Project Name: MS 5 Loudoun County Public Schools (July 31, 2008 KL)

Re: SPEX 2008-0017, CMPT 2008-0007, LCSB Lenah Property, Archaeological Study

**Re: SPEX 2008-0017, CMPT 2008-0007, LCSB Lenah Property, Resubmission for
Planning Commission Public Hearing**

RE: **Lenah Schools**
SPEX-2008-0017 and CMPT-2008-0007
BCG Project Number 3486-02-006

SCHEMATIC BIORETENTION EXHIBIT

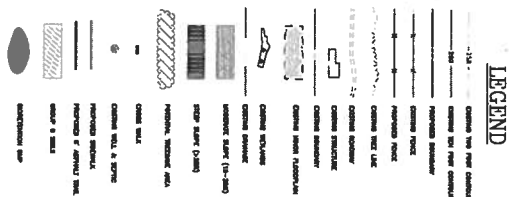
1. *"The stormwater design relies almost exclusively on inlets, pipes and dry ponds with impermeable subsurfaces, leaving little opportunity for maintaining site infiltration as requested by County staff and Loudoun Water staff. Maintaining infiltration is important to maintain groundwater levels used to supply water to the Lenah subdivision. An application's impact on groundwater supply is also an issue for consideration, per Zoning Ordinance Section 6-1310(M). Accordingly, staff has the following suggestions for stormwater design to resolve this outstanding issue:*

- *Reconsider using permeable parking surfaces for the bus parking area near the northern project boundary and the general parking area between the middle school and baseball diamond. Such surfaces are considered permeable and do not require further Best Management Practice treatment. Detention designs under the parking surface can store and convey excess runoff if soils lack permeability needed for complete infiltration.*

- *The site plan shows significant vegetation and berm design between the north parking lot and Lenah Road. Staff recommends incorporation of bioretention basins (with underdrains if soils are not sufficiently permeable) for the parking lot and roof runoff conveyed through pipes in this area. Vegetation that is required for BMP purposes within the basins can be irrigated by runoff instead of potable water and also meet Type 2 buffer requirements. Other grass and treed areas in the buffer can be irrigated from a cistern(s) draining rooftop runoff. Office of Capital Construction includes a cistern design for the Brambleton Public Safety Center for rainwater reuse."*

Staff believes that implementing these recommendations will remove some or all of Pond 1. Staff also recommends a follow-up meeting with Building and Development staff, Planning, Loudoun Water, and LCPS to resolve stormwater issues.

Response: LCPS has concerns regarding the long term performance of permeable parking in these high traffic areas. The increased construction costs of this type of pavement are not compatible with current budget guidelines. LCPS concurs with the staff recommendation to provide bioretention basins and believes the appropriate solution to be infiltration based technology including bioretention basins/filters for areas outside of the pavement structure.

To this end, LCPS is agreeable to providing bioretention basins/filters between the north parking lot and Lenah Road, to the extent that it does not significantly impact berming along Lenah Road. LCPS has worked in good faith with residents of the Lenah Run Community to provide a substantial landscape buffer that will provide an attractive appearance along Lenah Road. Underdrains will be provided as necessary. LCPS further proposes BMP at the northwest corner of the site to mitigate the potential runoff from athletic fields. This BMP will consist of either the retrofit of the existing pond to a 65% efficient BMP facility contingent upon Corps of Engineers/DEQ approval, or the provision of sediment forebays and a bioretention facility adjacent to the pond.

We agree that Pond #1 will be reduced in size although we believe it will still be required for detention purposes.

(See Attached Exhibit)
